New Orleans St. Bern. G 1 to G 105
LAKE PONTCHARTRAIN, LA. AND VICINITY
CHALMETTE AREA PLAN

DESIGN MEMORANDUM No. 3
GENERAL DESIGN

SUBJECT: Lake Pontchartrain, La. and Vicinity, General Design Memorandum
No. 3, Chalmette Area Plan

LMVED-TD (NOD 1 Nov 66) 1st Ind
SUBJECT: Lake Pontchartrain, La. and Vicinity, General Design Memorandum
No. 3, Chalmette Area Plan

1 Incl (dupe)
3. Sketch

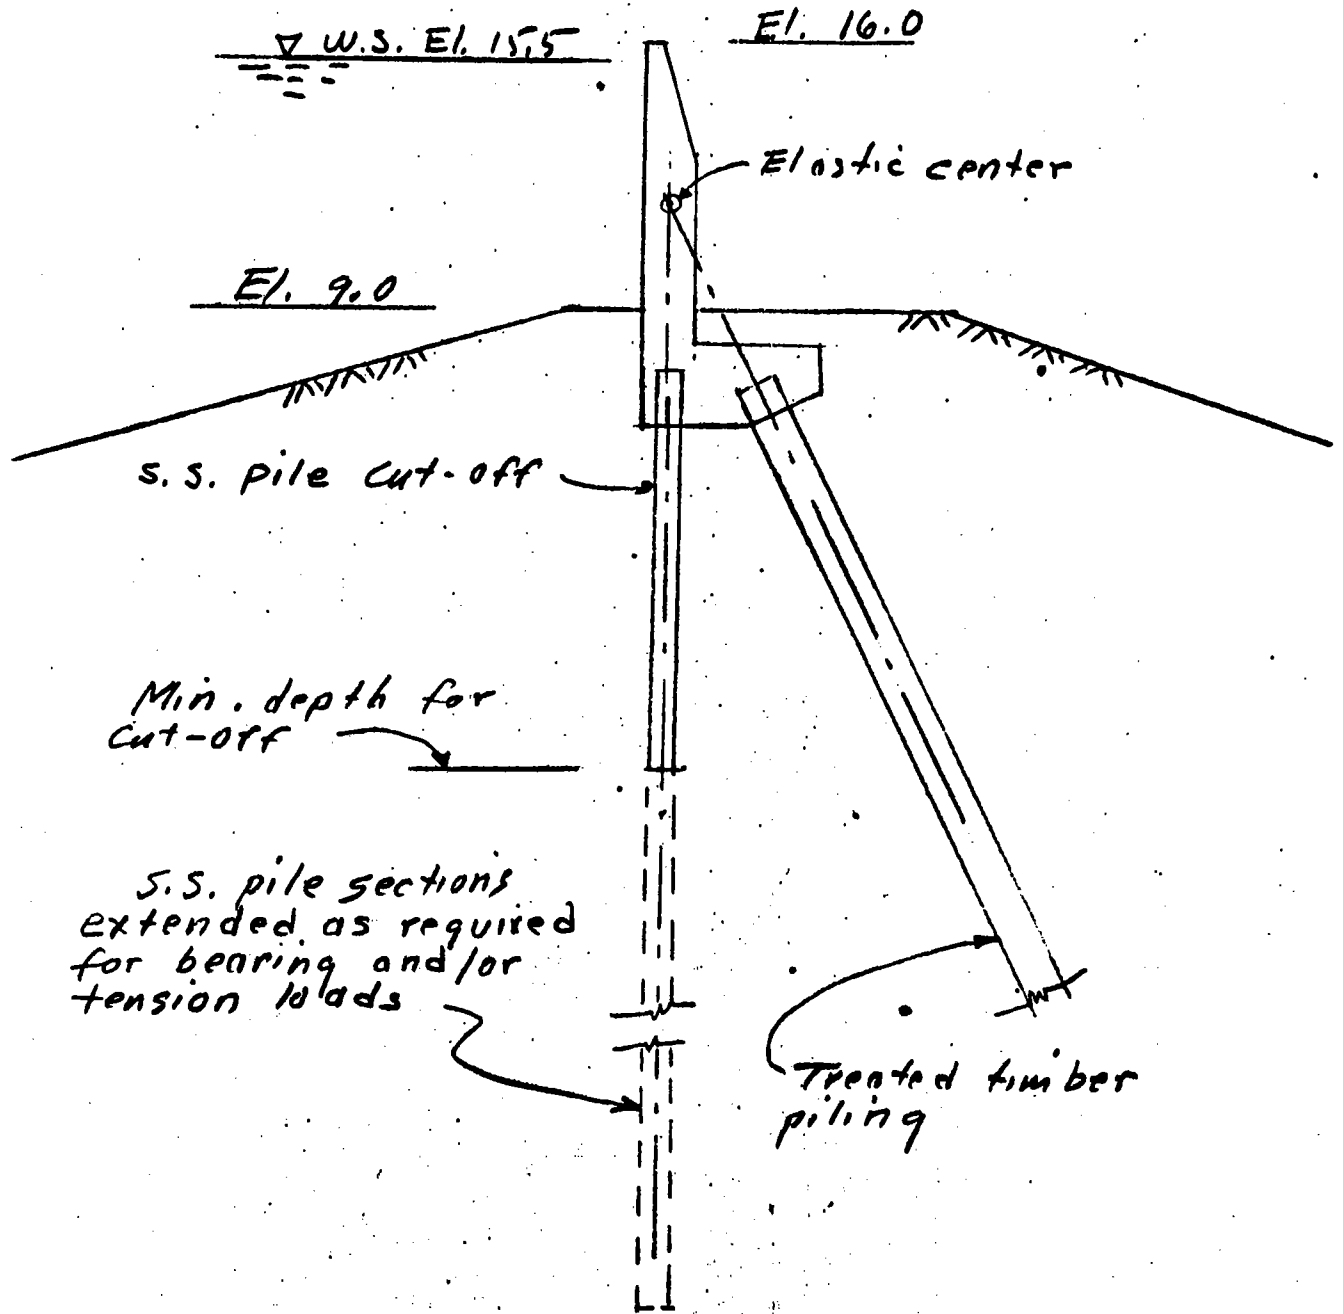
11. Plate 22. Consideration should be given to a wall section using a pile arrangement as shown on Incl 2. This type section will provide a greater vertical component of the wall load and reduce or eliminate tension in the piles battered upstream. The pile loads would be determined by the Culmann method.

PLAN AND PROFILE
Sta. 1+82 to Sta. 0+00 (10' O.S.) =
Sta. 1+46.6 to Sta. 12+00

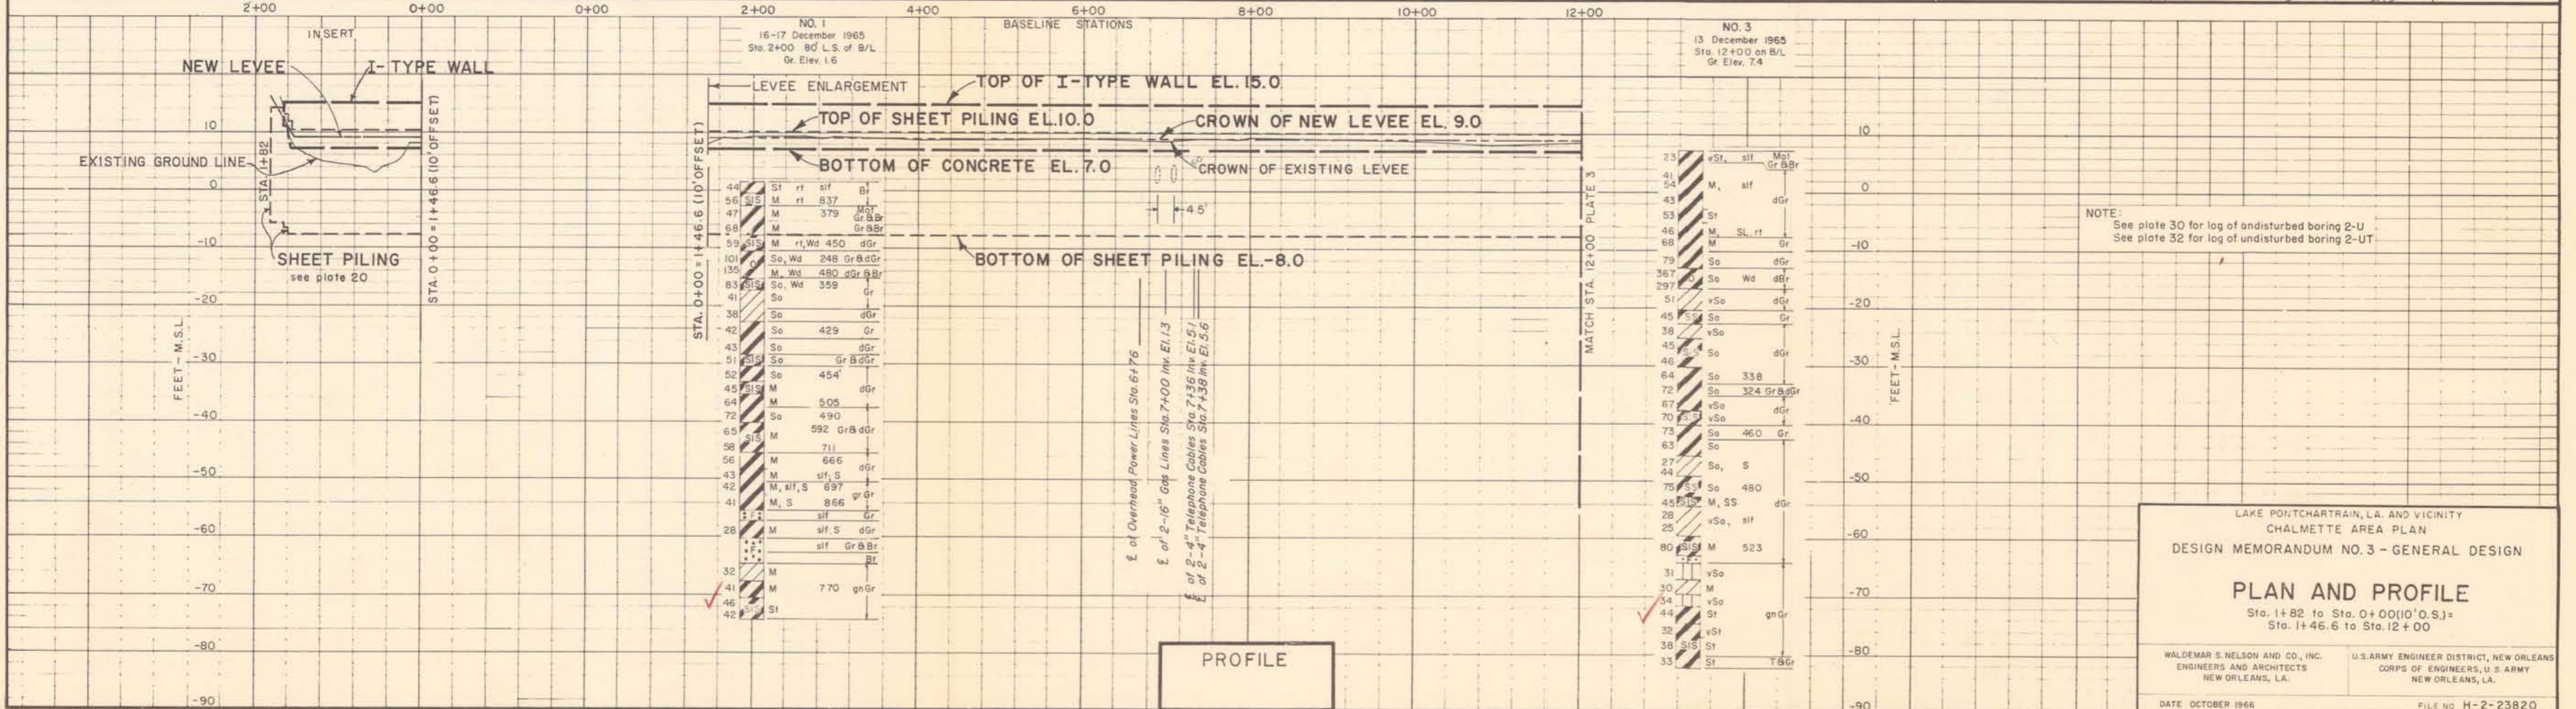
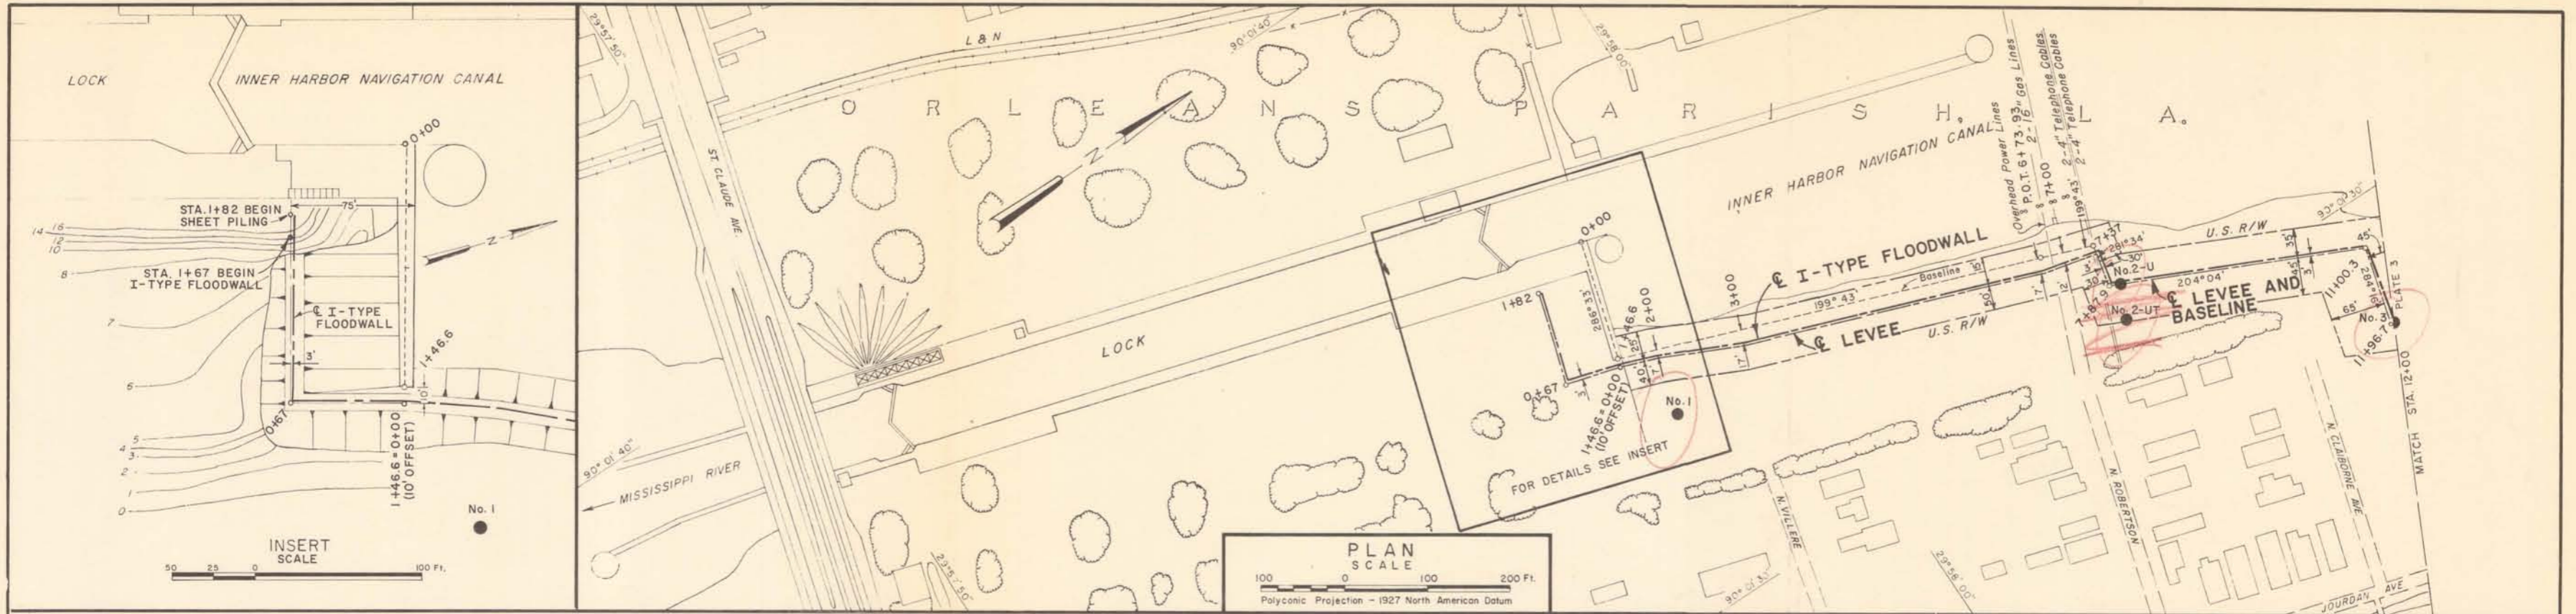
3. Paragraphs 11 and 43 and Plates 5 and 6. Design and alignment in the vicinity of Florida Avenue are not satisfactory. They should be restudied to develop a plan which is compatible with proposed improvement of the navigation canal, which will require a new longer lift bridge at Florida Avenue or a separate higher level highway bridge and a movable bridge span for the railroad. In this connection, reference is made to 2nd Indorsement ENGCW-EZ, 8 December 1966 on letter LMNED-PP, 15 September 1966, subject: "Mississippi River-Gulf Outlet, La. - Report on Need for New Ship Lock", (especially paragraph 5a(3) and (6)). If interim protection is required, it should be recognized as such and the plan for permanent protection developed compatible with the navigation canal improvement.
